MC/ACF/Fire Detection/AC

Sub: Power supply and MCB of FSDS System.

No. EL/6.8.21

Sub: Guidelines for continuous power supply to fire and smoke Detection System (FSDS) shall be provided from terminal Block (TB) X1 of Switch Board Cabinet (SBC).

DRG NO. RDSO/PE/SK/AC/0206-2019 (Rev. 0) SHEET. 11 OF 48

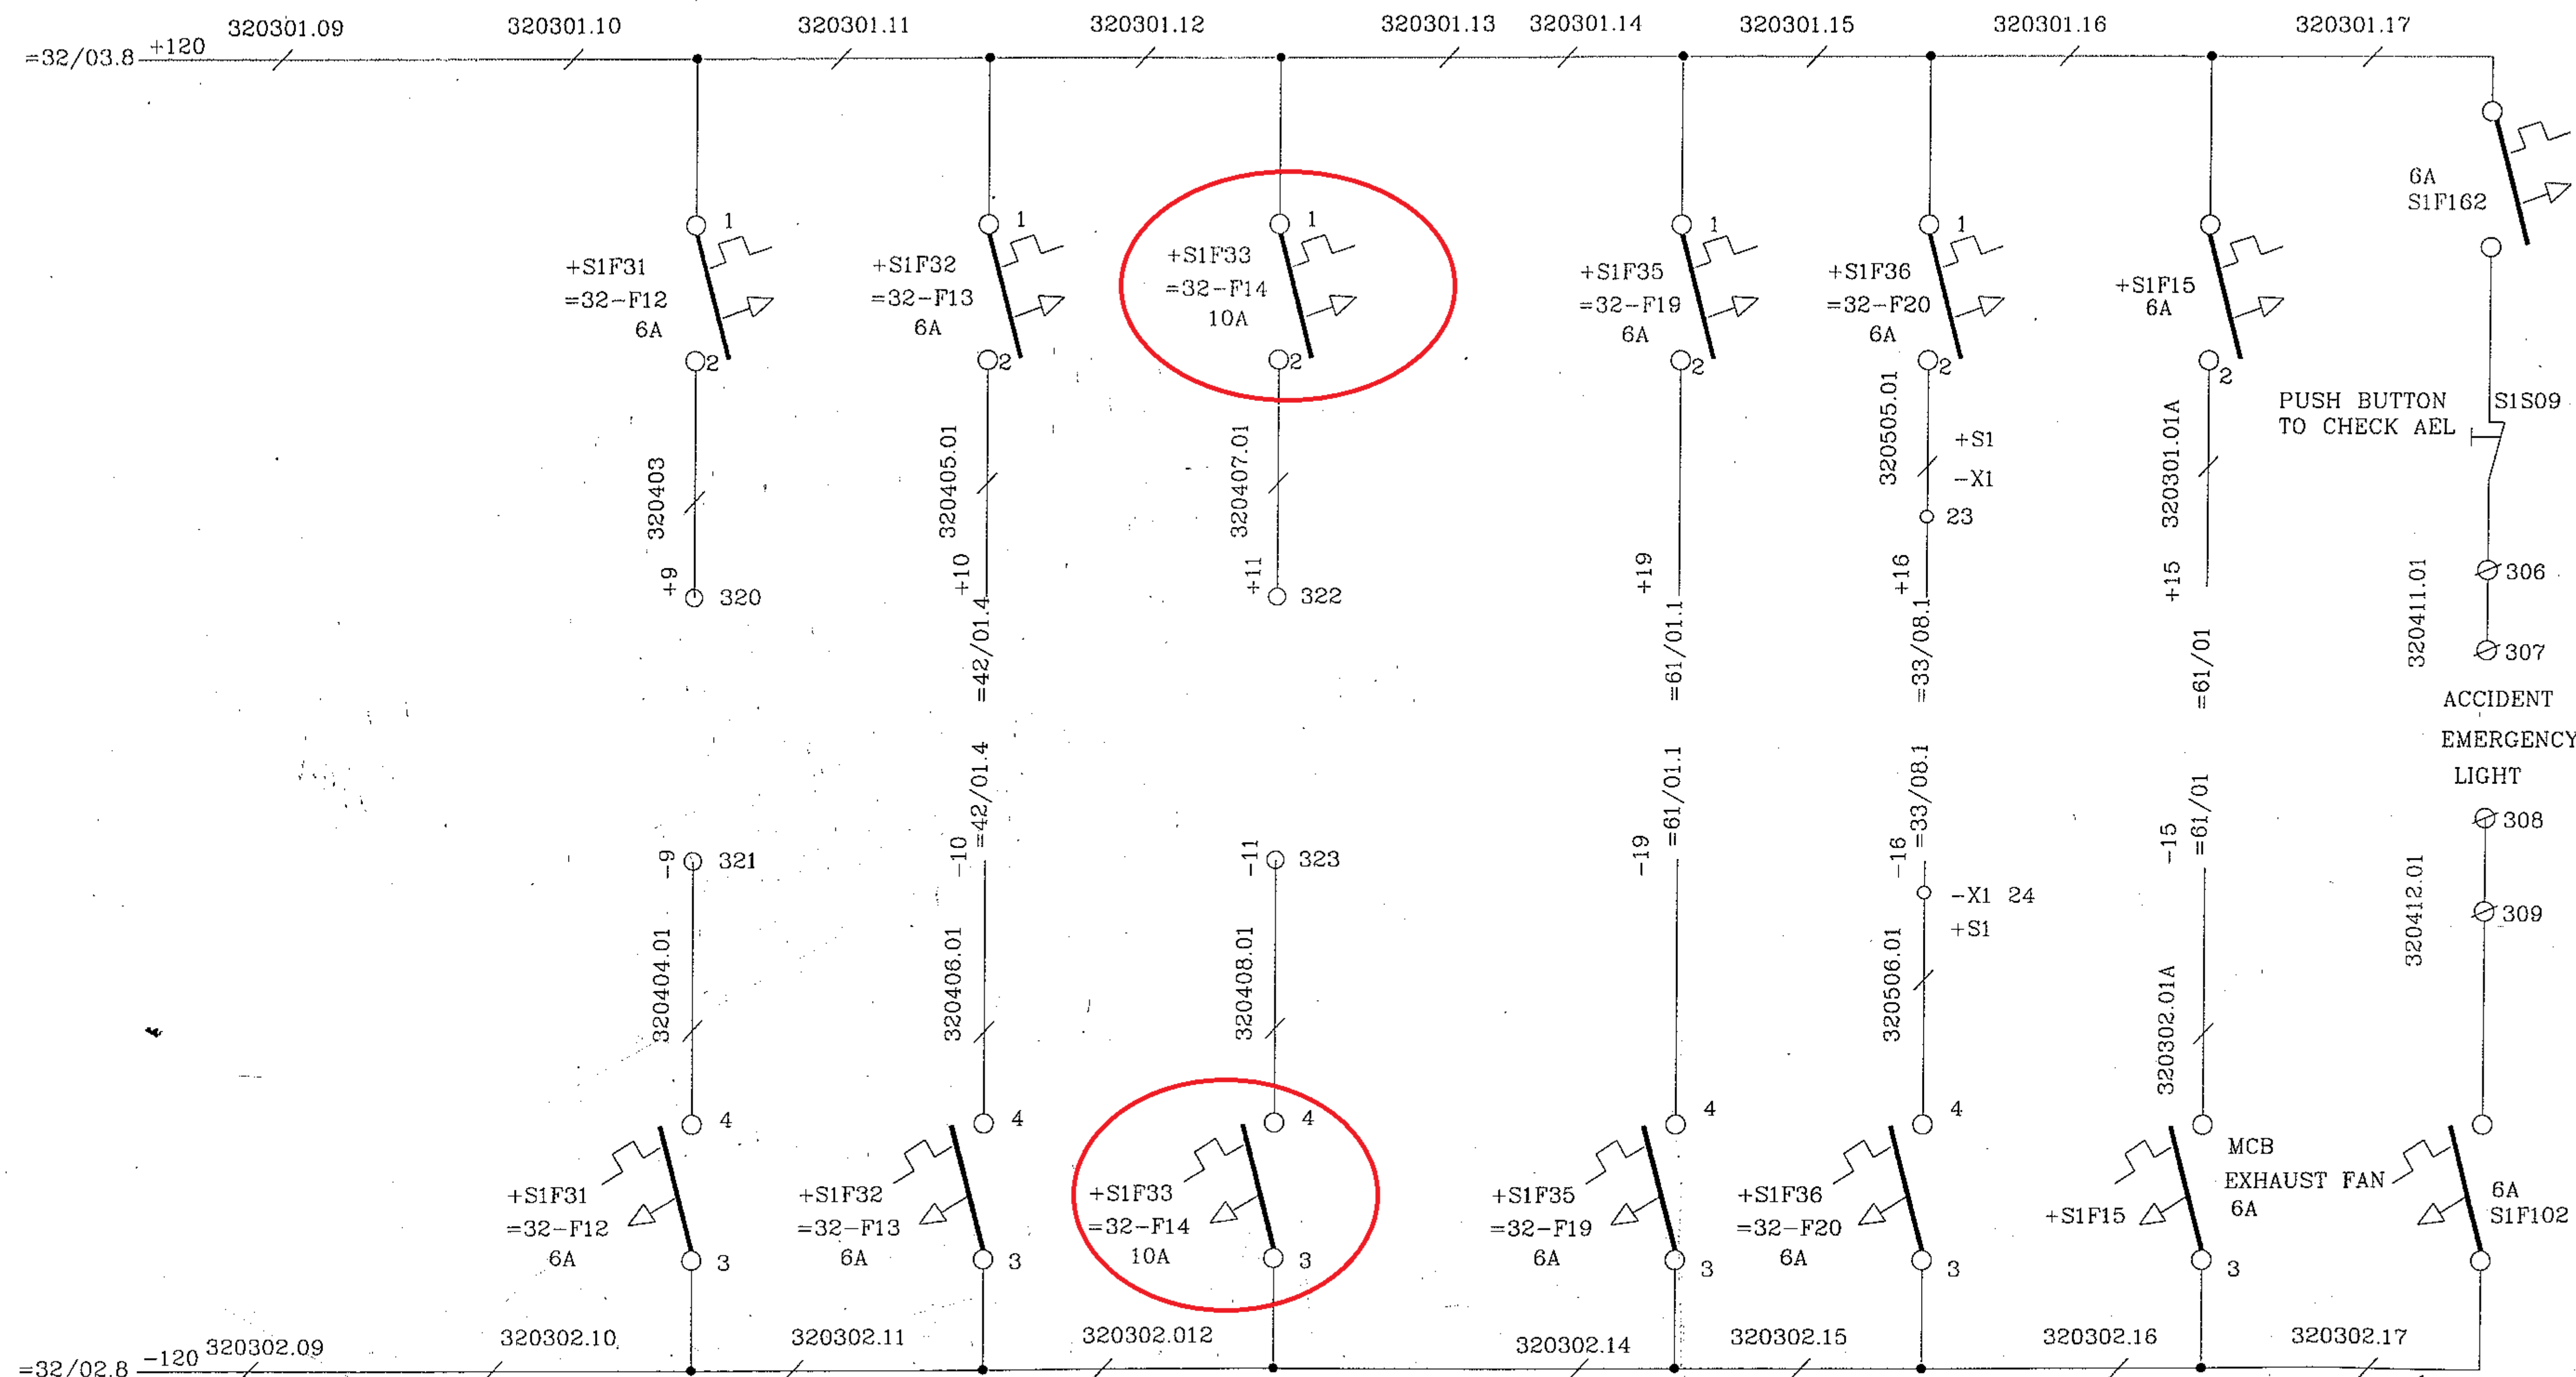
S. No.	Type of Coach	Place of Installation
i	LHB variant of AC coaches.	Supply may be taken from the place of installation of MCB S1F33 with 2A, 2P, C-curve, 110V DC MCB. The indication of MCB in Sheet no. 11 of 48 of RDSO drawing no. RDSO/PE/SK/AC/0206-2019 (Rev.0) attached as ANNEXURE A
ii	ICF type SG AC coaches	Dedicated 2A, 2P, C-curve 110V DC MCB to be provided after the common 40A DC MCB as shown in RCF drawing no. CC70401 (Copy enclosed). The MCB to be placed in The Power Panel besides other DC MCBs. New 2A MCB provided to be marked as FSDS. The indicated drawing is attached as ANNEXURE B
